Appendix I of RNTPC
Paper No. A/YL-KTN/816

**APPLICATION FOR PERMISSION
UNDER SECTION 16 OF
THE TOWN PLANNING ORDINANCE
(CAP.131)**

| Applied use/ development 申請用途/發展 | 擬議臨時公眾停車場(不包括貨櫃車, 為期3年) 及填土 | |

Re: Planning Application No. A/YL-KTN/816_Departmental Comments

布局設計圖

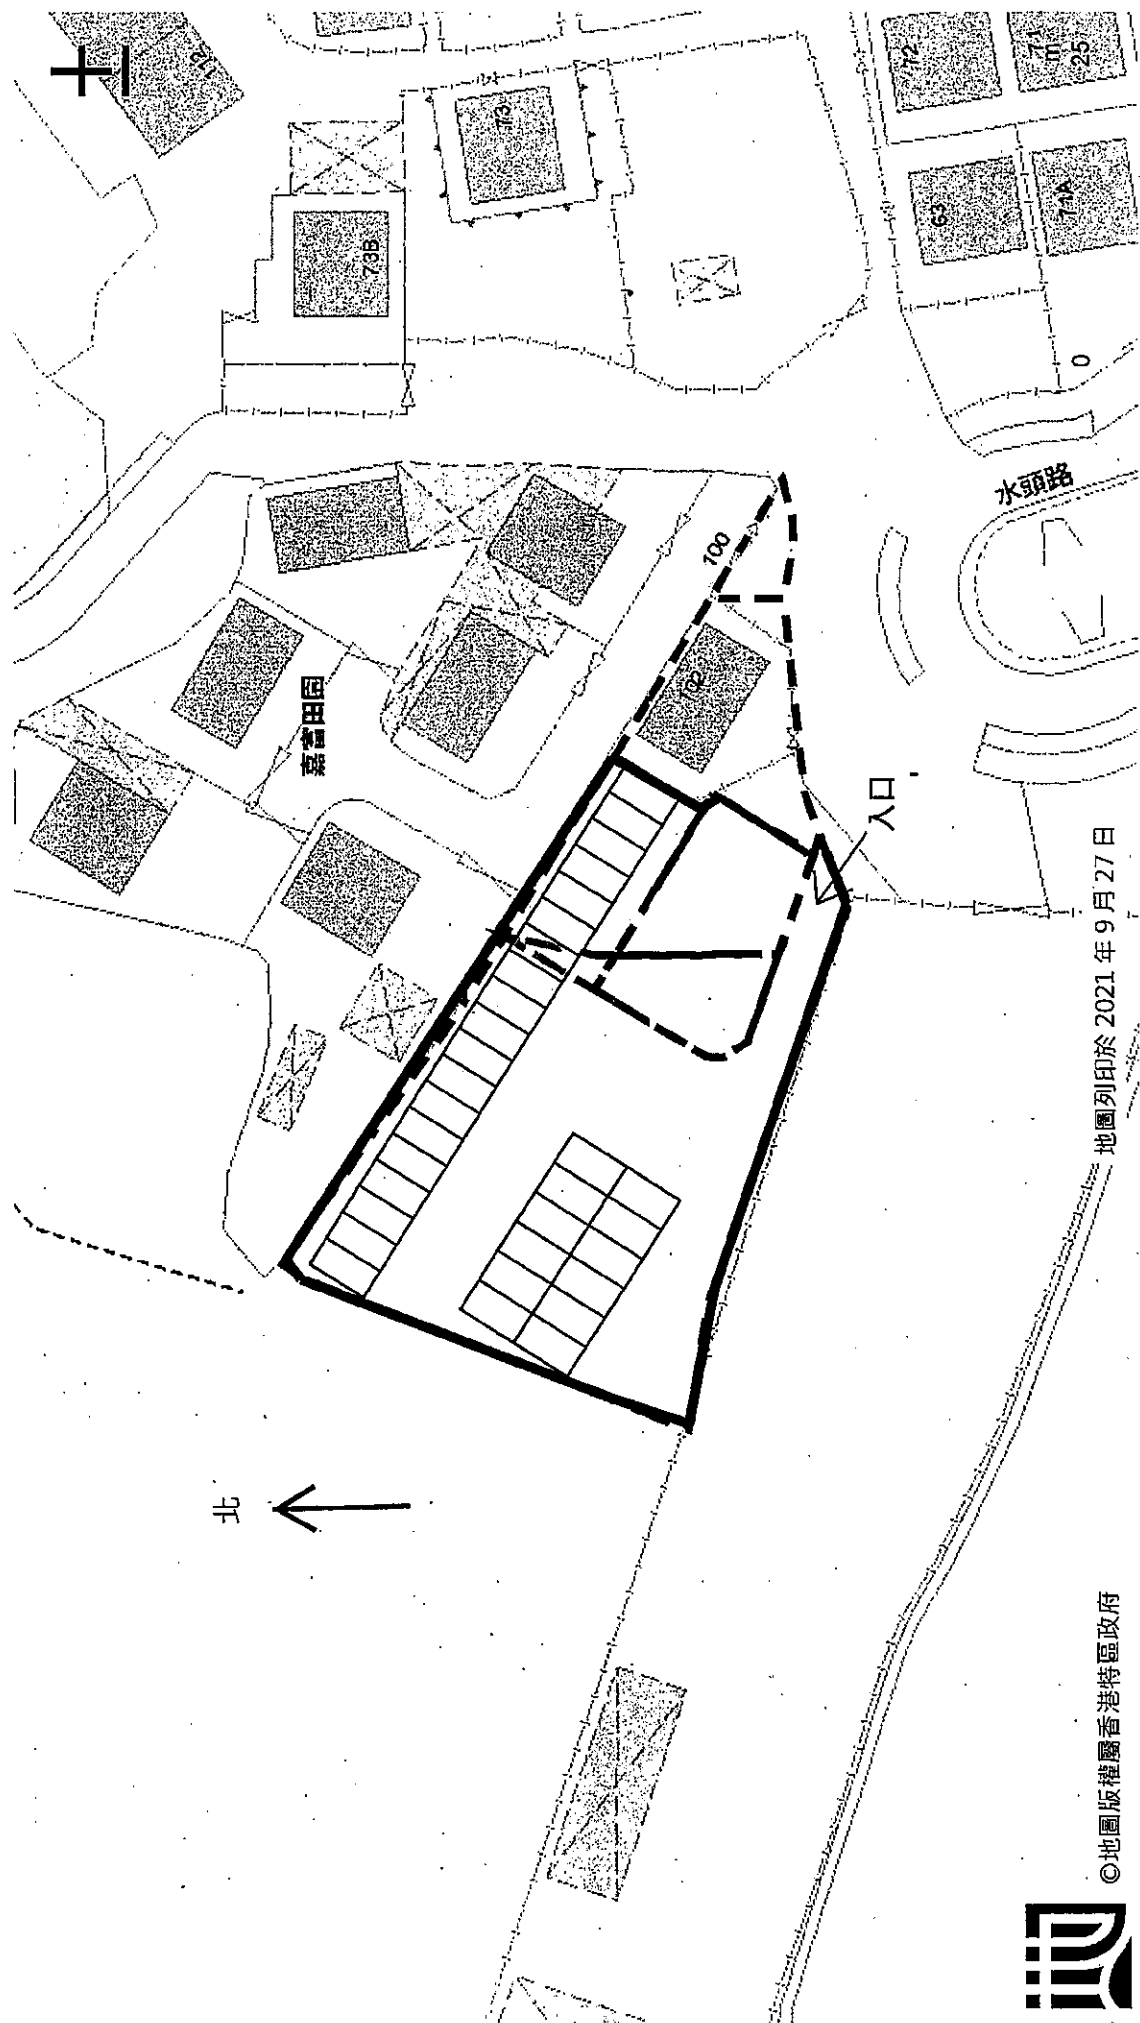
(c) The applicant should demonstrate the smooth manoeuvring of vehicles to/ from Chi Ho Road, along the local access and within the Site.

The condition of Shui Tau Road is good enough for vehicles to/ from Chi Ho Road. Photos are attached for your reference:
